Video8

B-mechanism know-how

8 MECHANISM DECK

Contents

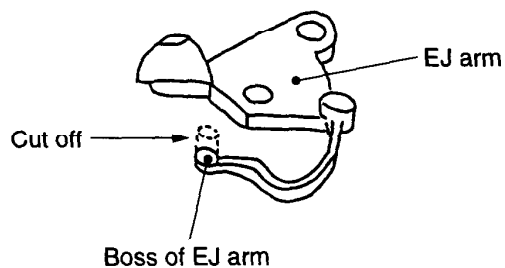
C-IN (C.C. LOCK) SW is always ON and tape is loaded in the state of cassette compartment UP.

EJ arm is deformed at the time of assembling and the boss on the spring is caught in LS chassis, and SW is kept pressed.

Cut off the boss that is caught in LS chassis of EJ arm.

Replace EJ arm.

14

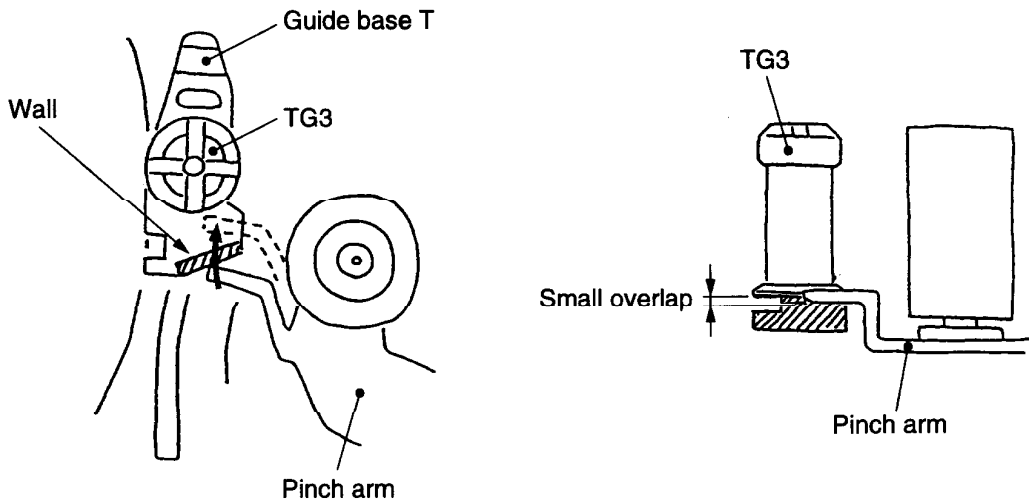
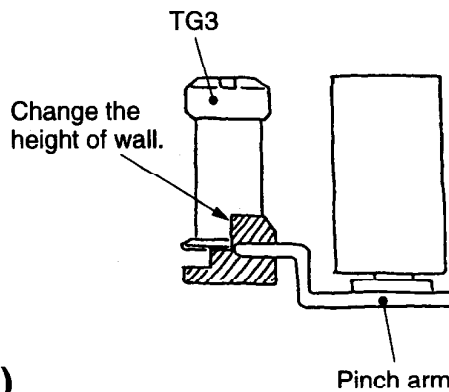
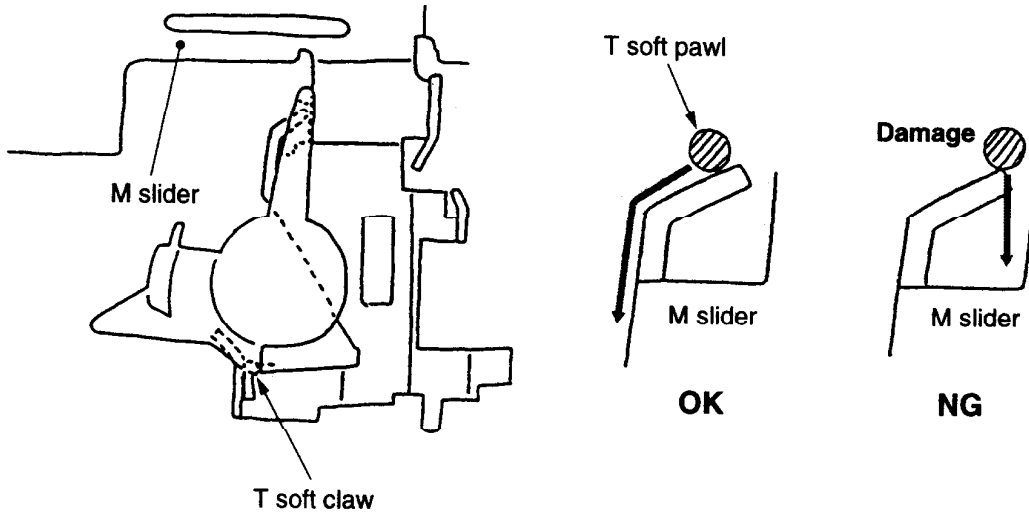
Tip of pinch arm gets over the wall of guide base T and enters between guide base T and TG3.
(Trouble with pinch arm) (Cause No. 7 of Figure 3)

The tip of pinch arm gets over the wall of guide base T and enters between guide base T and TG3, causing loading failure.

The amount of overlap of the tip of pinch arm and the wall of guide base T is small.

Change the height of wall of guide base T to obtain margin to the tip of pinch arm.

Replace pinch arm with improved part.

(Former)
A-7040-418-A

(New)
A-7040-418-B

T soft brake not working, trouble at loading/unloading
(Damage to T soft claw) (mis-aligning M slider)

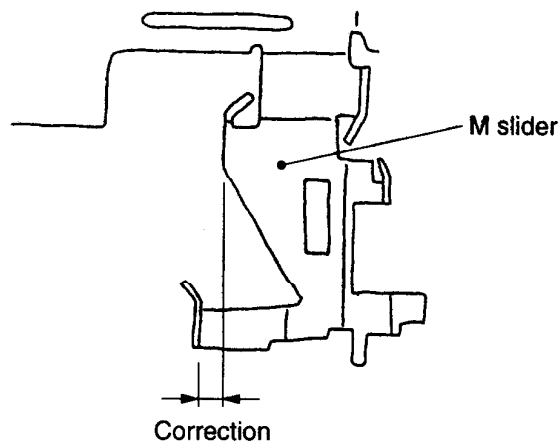
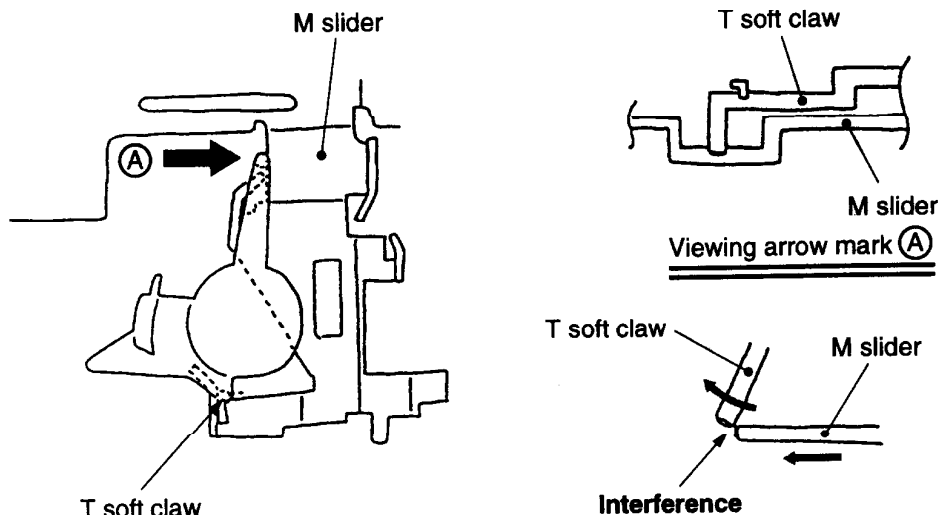
The shaft at tip of T soft claw is caught in the bent portion of M slider and damaged at the time of unloading. T soft brake is not working or is caught at loading/unloading.

Insufficient margin due to variation of the position of bent portion of M slider.

Correct the width of bent portion of M slider.

Replace M slider ass'y.

Problem with M slider and T soft claw
(T soft brake torque becomes small)

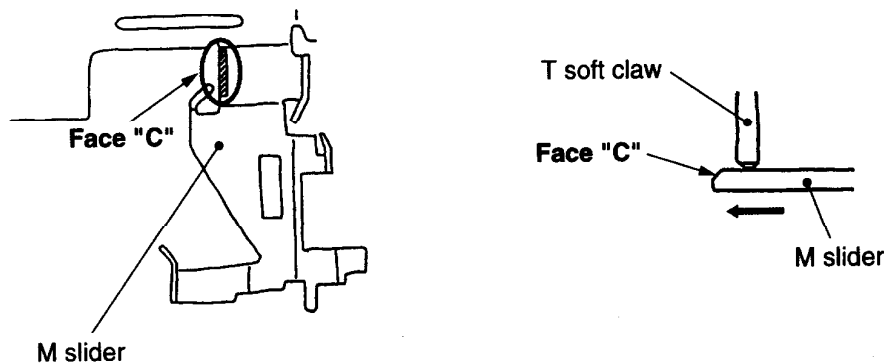
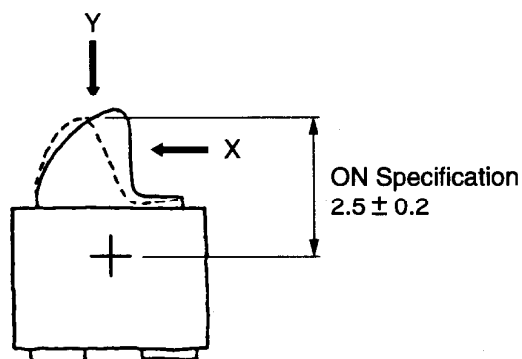
The tip of T soft claw interferes with the corner of M slider at loading, and T soft brake torque (failure of T soft brake) becomes small.

Insufficient margin of clearance between the tip of T soft claw and M slider in the direction of height.

Add face "C" to the position that touches T soft claw of M slider.

Replace M slider.

17**"No cassette" displayed on cassette deck****(Symptom)**

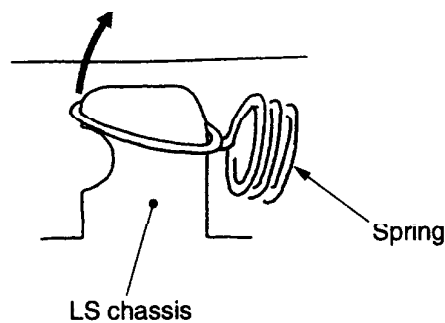
C-IN SW (C.C. LOCK) is not ON at cassette DOWN and "No cassette" is displayed.

Insufficient margin of stroke at ON point of C-IN SW

1. SW ON point specification differs from standards of using MD.
2. Clearance between SW lever dowel and case hole is large, causing improper fit.

Replace SW with improved C.C. LOCK switch (1-572-680-11).

18**Damage to tape due to slack of T side tape
(Separation of T soft gear spring)****(Symptom)**

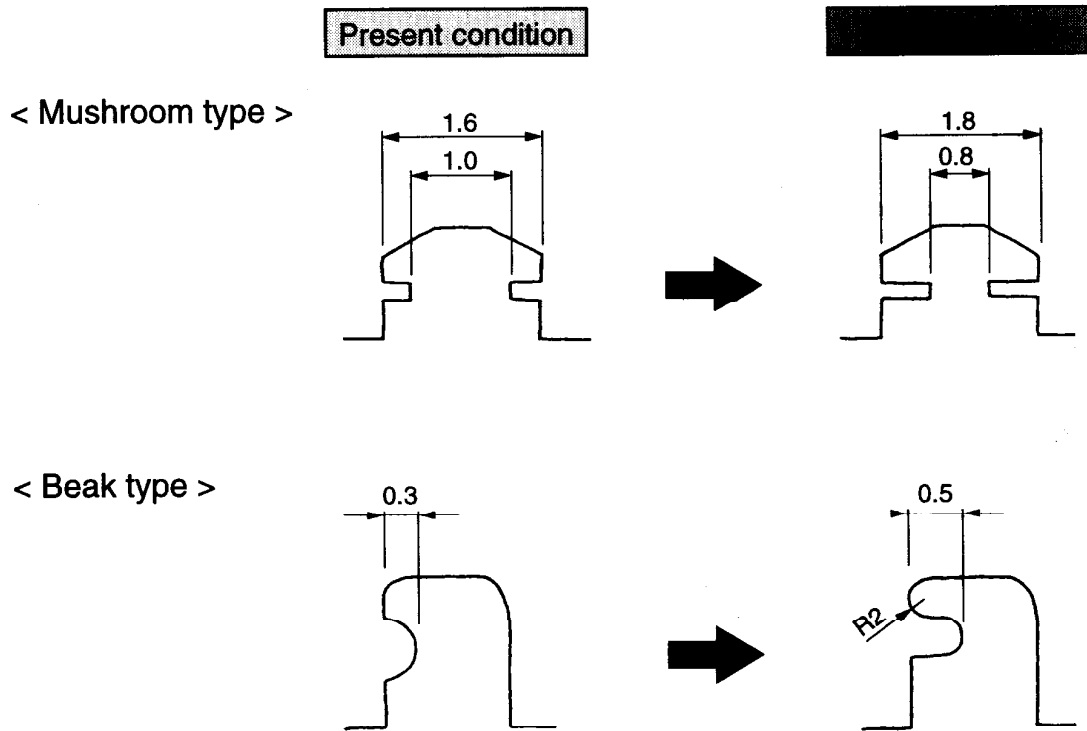
LS chassis spring is separated, causing incorrect operation (spring is caught by entry of foreign objects). Poor picture quality. (decrease in tension, etc.)

1. Spring is separated due to failure of hooking the spring claw (improper assembling).
2. Spring is easily separated by a touch of spring claw due to incorrect phase of spring hook or small overlap between LS chassis spring claw and spring hook.

1. Push spring hooks with jig and check (prevention of hooking failure).
2. Change the shape of spring claw to increase overlap between spring claw and spring hook, and margin UP against separation of spring.

- Mount the spring hook correctly to prevent separation (repair).
- Improved parts are available from our stock.

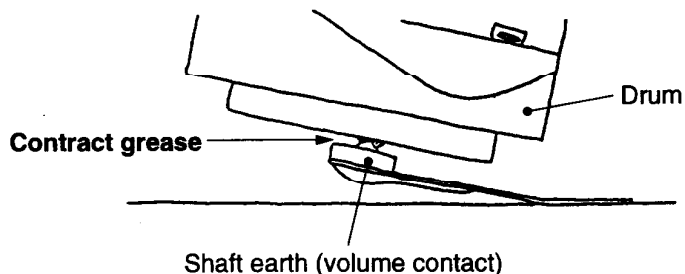
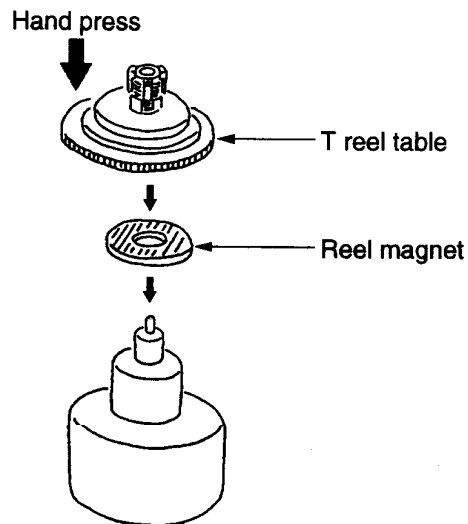
Camera picture swings at ON of steady shot compensation.

Shaft earth vibration interferes with the oscillation frequency of angular velocity sensor during drum rotation, causing failure in operation of steady shot preventive sensor and swinging of camera picture at ON of steady shot compensation.

1. Apply grease to the tip of the volume contact of shaft earth.

2. Replace shaft earth with improved part.

(Former)
3-965-525-01

(New)
3-965-525-03

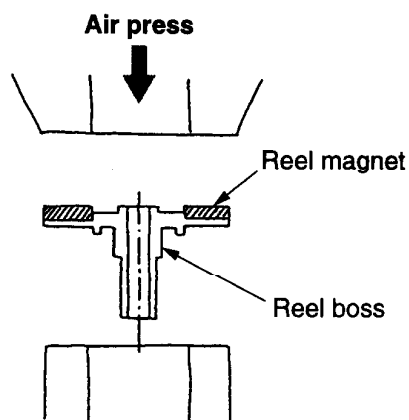
Adhesive force of S/T reel table rotation detect magnet seat is insufficient, causing separation of magnet and resulting in caution (reel table rotation cannot be detected) or rotation failure.

Magnet seat was stuck by a press of reel table boss with hand, causing variation in adhesive pressure and separation of reel table magnet.

Use air press machine to obtain constant pressure on magnet seat for improvement.

Replace reel table.

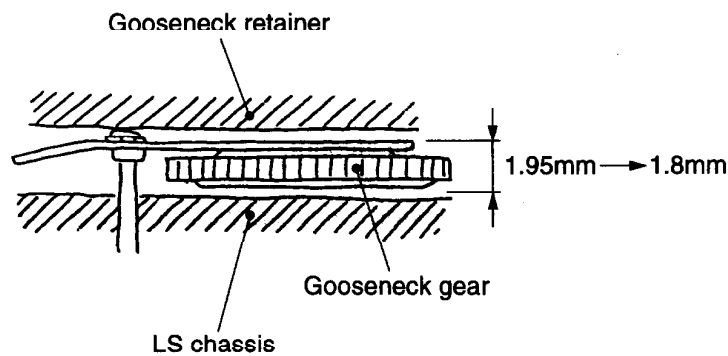
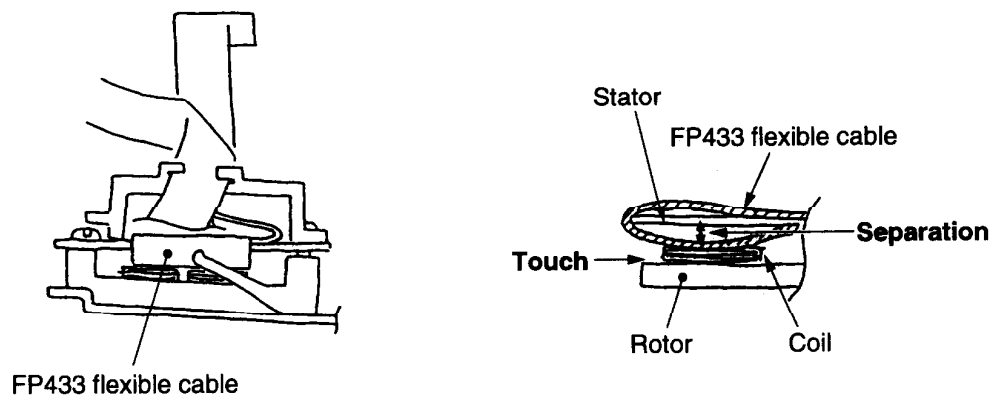
Gooseneck gear is caught between gooseneck retainer and LS chassis due to deformation of gooseneck retainer, causing failure in operation of gooseneck gear.

Insufficient margin of clearance between gooseneck retainer and LS chassis, and the thickness of gooseneck gear.

1. Change the thickness of gooseneck gear, from 1.95 to 1.8mm.
2. Change the height of foot of gooseneck retainer + 0.05mm (from 2.20 to 2.05mm, clearance between foot and LS chassis is "0").

Replace gooseneck gear.

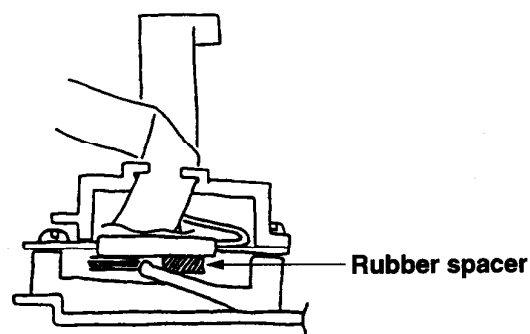
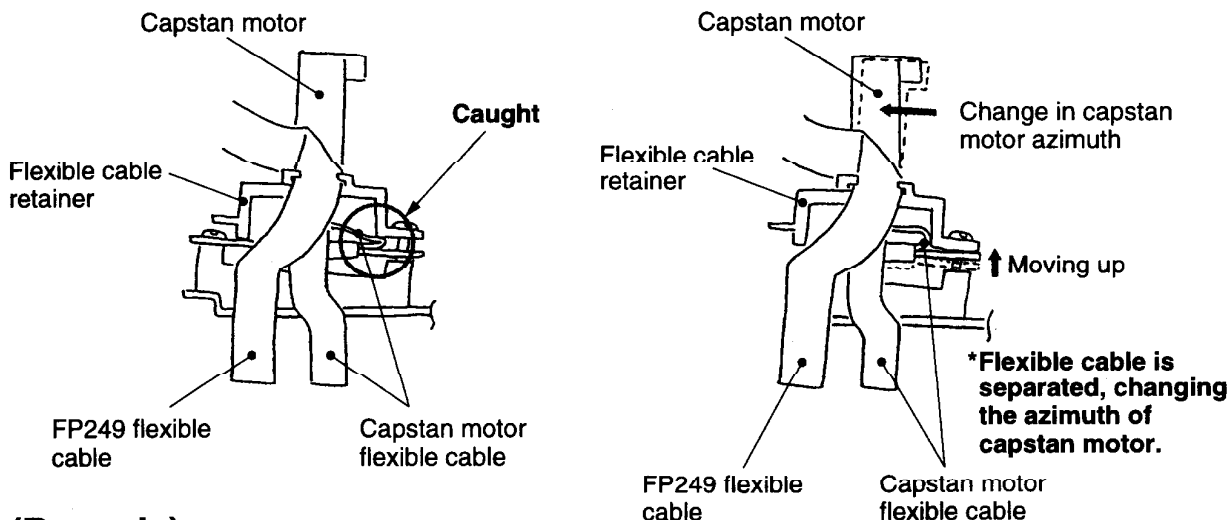
Coil mount of FP433 flexible cable of capstan motor is floating and the coil touches the rotor, causing unusual noise, incorrect rotation and swinging of picture.

Adhesive power of FP433 flexible cable is reduced due to oil which was left at the time of pressing the capstan motor to the stator.

1. Clean stator (driver IC side) with alcohol.
2. Add rubber spacer between flexible cable and capstan spacer (Mount side) to forcedly prevent the flexible cable from floating.

1. Clean the stator.
2. Add rubber spacer. **3-987-953-01**

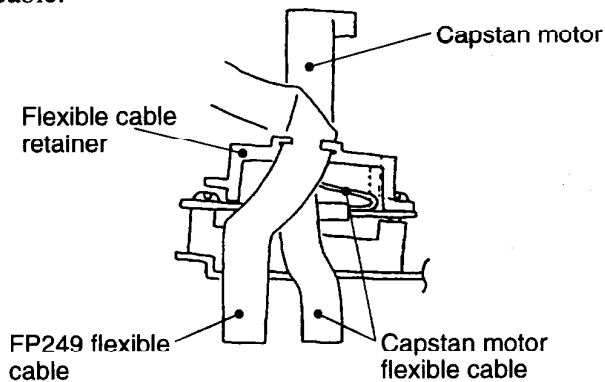
Tape damage/wrinkle due to change in capstan motor azimuth.

The folded portion of capstan motor flexible cable is caught and released at the time of assembling the flexible cable retainer, causing tape wrinkle or damage due to change in capstan azimuth and bending of tape.

Change the shape of flexible cable retainer to prevent overlap of flexible cable retainer and capstan motor flexible cable.

Repair flexible cable.

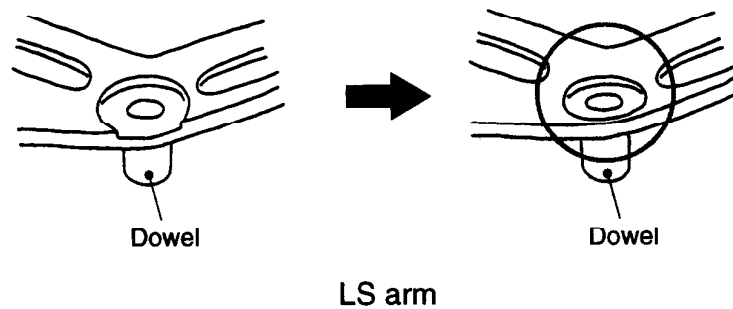
LS arm pin is deformed, causing failure in loading/unloading operation.

1. The set was dropped off, causing overload on the dowel of LS arm in the groove of cam gear.
2. LS chassis was forcedly pulled out by user for unloading when unloading failure occurred by tape jamming, caution, etc.
3. LS chassis was pressed forcedly (in the direction of loading) by user during loading/unloading.

1. Change the dowel of LS arm from choked type to forged type.
2. Change the shape of the base at the root of dowel.

Replace LS arm **3-965-532-21**

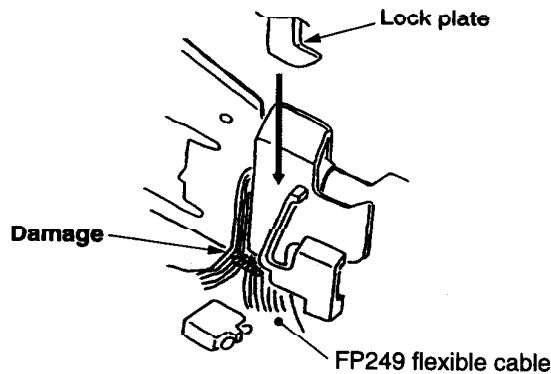
Playback output of one CH becomes small due to difference in output of CH1/CH2, causing noise (white noise, dot noise, etc.) in LP picture.

The upper drum is tilted due to clearance between drum bearing and shaft, so the height of CH1/CH2 head becomes out of position, causing difference in the pitch of CH1/CH2 of recording pattern and small playback output from one CH, which largely affects LP due to narrow track width even when the amount of pairing slip is the same.

Change the drum bearing and shaft from insertion type to press-in type to prevent inclination due to clearance.

Replace drum ass'y.

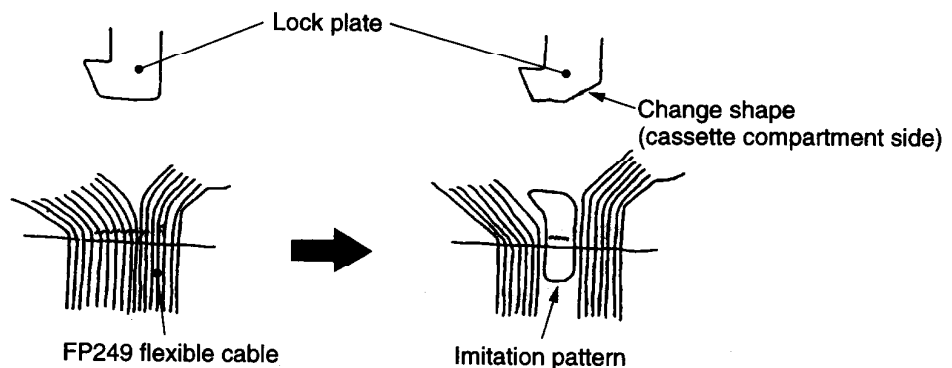
FP249 flexible cable is damaged by cassette compartment lock plate, causing failure in the sensor system for reel rotation detection, C.C. LOCK, etc.

Cassette compartment lock plate was pressed to FP249 flexible cable due to over-stroke at cassette compartment DOWN, and FP249 flexible cable was cut off by pressure.

1. Change pattern of FP249 flexible cable to prevent the signal pattern from touching the lock plate.
2. Add imitation pattern to the position in contact with the lock plate of FP249 flexible cable for reinforcement.
3. Change the shape of tip of lock plate to reduce the area of contact with flexible cable.

If flexible cable is found damaged by microscope or magnifier, replace chassis (S1) ass'y even when the same trouble does not occur again.

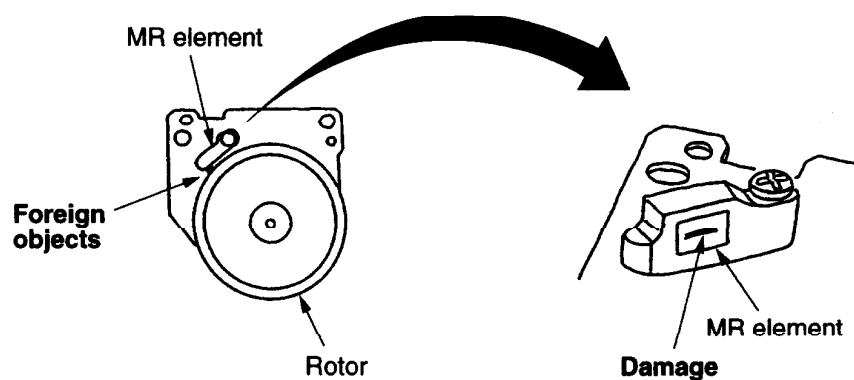
Loading motor is not rotating due to short-circuit between slits of loading motor. Fuse blows out (due to short-circuit between terminals) and power cannot be set to ON.

The slits were shorted by abrasion powder from worn commutator of loading motor and the paint chips on lapping tape dropped off at the time of lapping the commutator, so the brush was contaminated with the mixture of paint chips and contact grease, causing in increase of wear of commutator and short-circuit between slits with the abrasion powder from the worn commutator.

1. Introduce ultrasonic cleaning.
Commutator lapping → Ultrasonic cleaning → Contact grease coating
2. Make arrangement to prevent deposit of foreign objects after coating contact grease.

Replace loading motor.

31

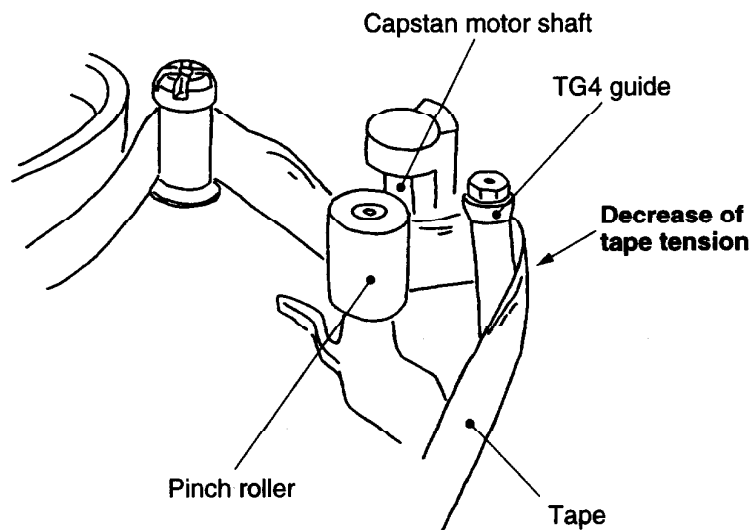
Guide base is separated when unloading, and is caught at the time of loading/unloading.

Stopper was deformed at the time of assembling and guide base was separated due to decrease in the amount of catching the guide arm.

S side Add a dowel to the stopper S to increase the holding force of GB stopper S and its margin at the time of deformation of the guide base.

Replace stopper S.

**TAPE DAMAGE DUE TO DISCREPANCY
IN TG-4 HEIGHT ADJUSTMENT**

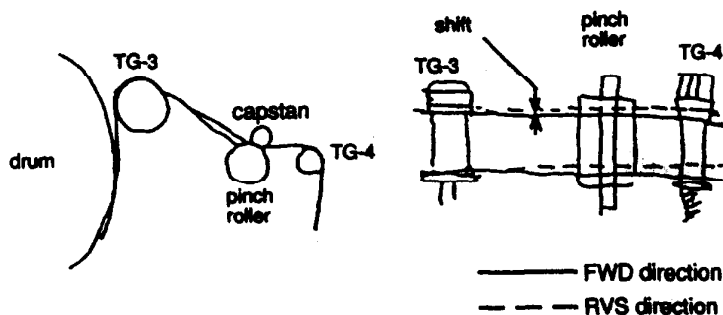
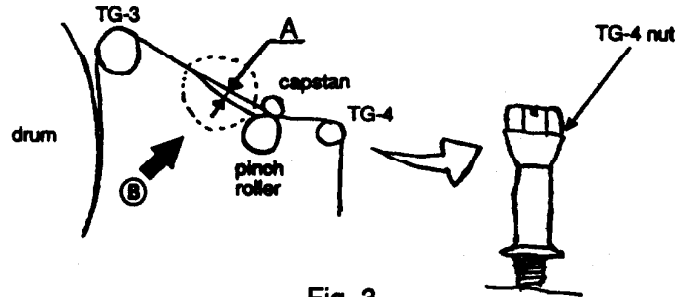
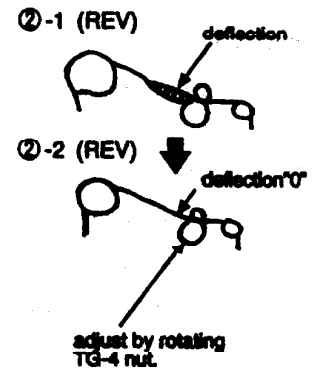
When repeatedly switching between PB and REV and between REC and STOP, tape damage as given below might be caused. (Fig. 1)

Discrepancy in the TG-4 height adjustment leads to more deviation of the height of tape running between the capstan and TG-3 in the FWD and RVS directions. This results in tape warp causing tape wrinkle to be produced by the pinch rollers. (Fig. 2)

- ① Run tape (regardless of the tape type) . View the part indicated by the arrow ⑧ from above the MD and place a point of view so that the upper edge and the lower edge of tape are aligned with each other and look like a line ($A=0$) at CUE.

- ② Keep the point of view, perform REV, and adjust the TG-4 height by rotating the TG-4 nut so that the width A produced due to deflection is zero.

- ③ Perform CUE/REV again and verify that the upper and lower edges of the tape are on the same position.

* If this adjustment cannot be made by rotating the TG-4 nut, the TG-4 nut should be replaced.
